SAN RAMON VALLEY RECYCLED WATER PROGRAM PUMP STATION R3000 PROJECT

Initial Study and Mitigated Negative Declaration

Prepared for
East Bay Municipal Utility District

June 2019

Figure 2
Potential Project Site and Construction Staging Area Locations

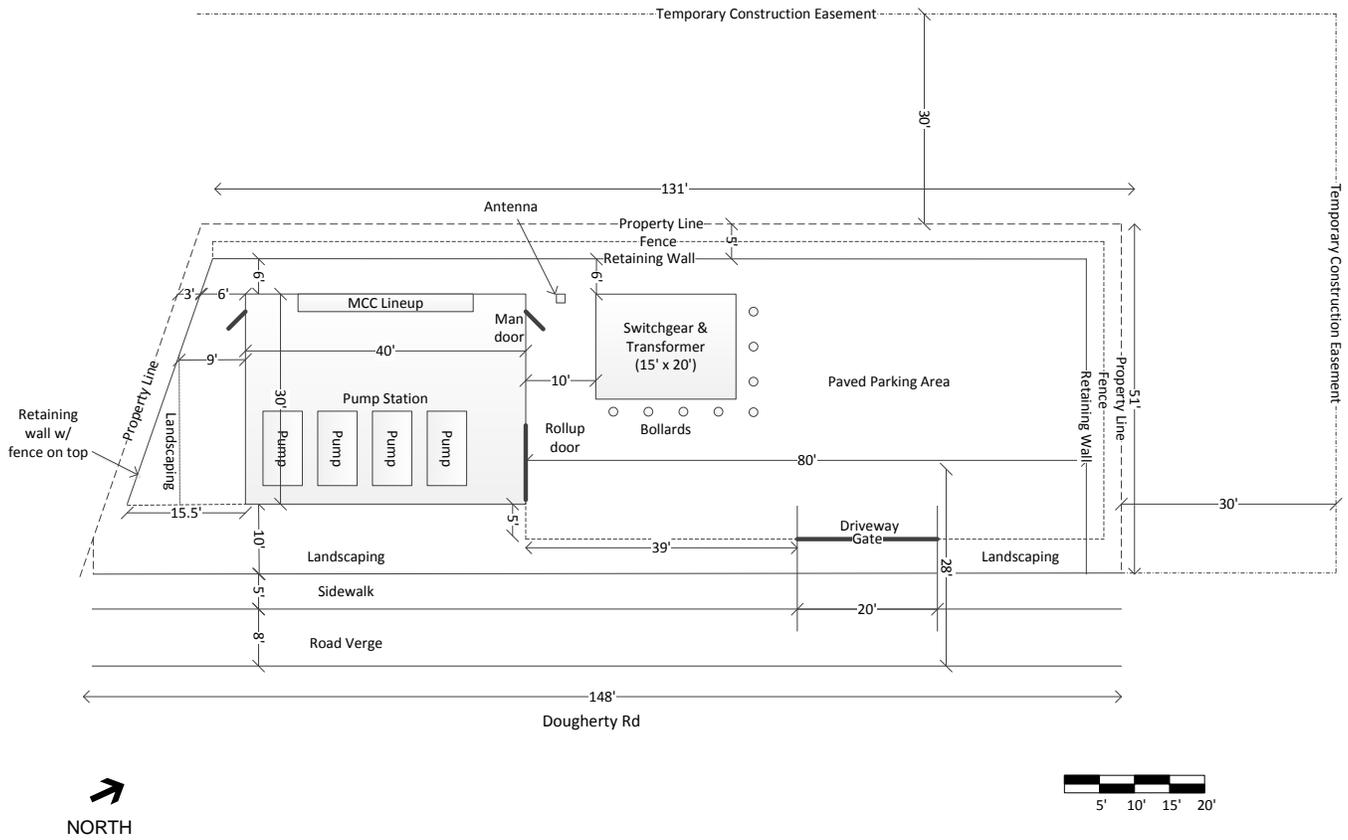
Bauer, L-16 This comment concerns the feasibility of using Staging Area 2 and the description of the staging area. Staging Area 2 is shown in the IS/MND, Figure 2 (page 1-4), is located on land owned by DERWA, includes a concrete pad approximately 50-feet-long by 40-feet-wide, and currently provides truck access to Reservoir R200. An additional unpaved area is available for material laydown at the site. The second bullet in the sixth paragraph under Section 1.5.1, Pump Station Construction, on page 1-13 of the IS/MND has been revised as follows to clarify the location of Staging Area 2:

Staging Area 2. The second potential staging area is the paved area approximately 170 feet ~~north~~ south of the Reservoir R200 (Staging Area 2 on Figure 2) and is located about one mile by road southwest of Site A2.

Figure 5
Site Views from Public Locations

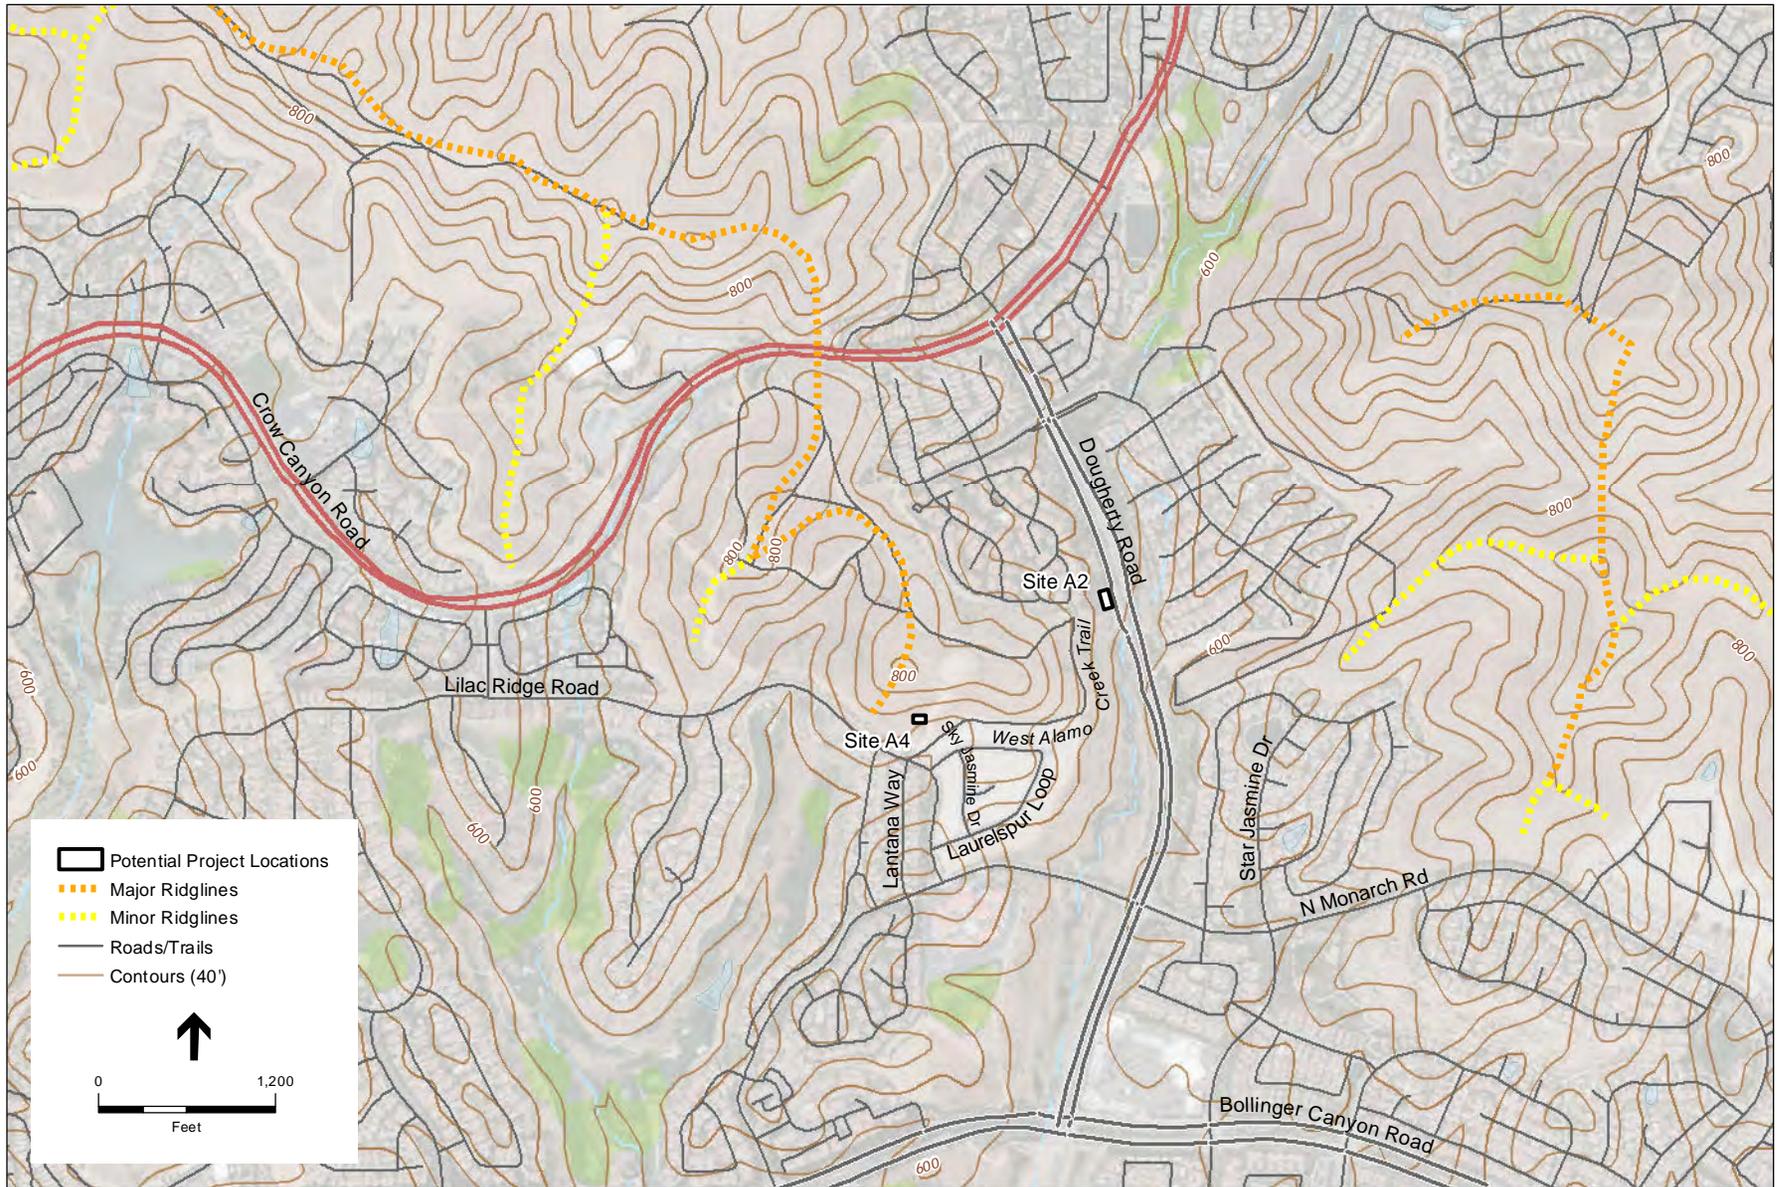
Bauer, L-17 This comment requests more information about the view of Site A4 from Lantana Way. As discussed in the IS/MND Section 2.2.1 Aesthetics (page 2-4), Site A4 is visible from parts of Lilac Ridge Road and Lantana Way, and slightly visible from the corner of Sky Jasmine Way and Laurelspur Loop. More people would experience (short-duration) views of the pump station at Site A4 from Lilac Ridge Road than from Lantana Way because there is more traffic on Lilac Ridge Road; consequently, that view was presented in the IS/MND in Figure 5.

Page 2-5. Figure 5. Why not also show a view looking north from on Lantana Drive? Photo 2 gives one no perspective of anything as it is framed. Do you not show 5901 Lantana Way on purpose?
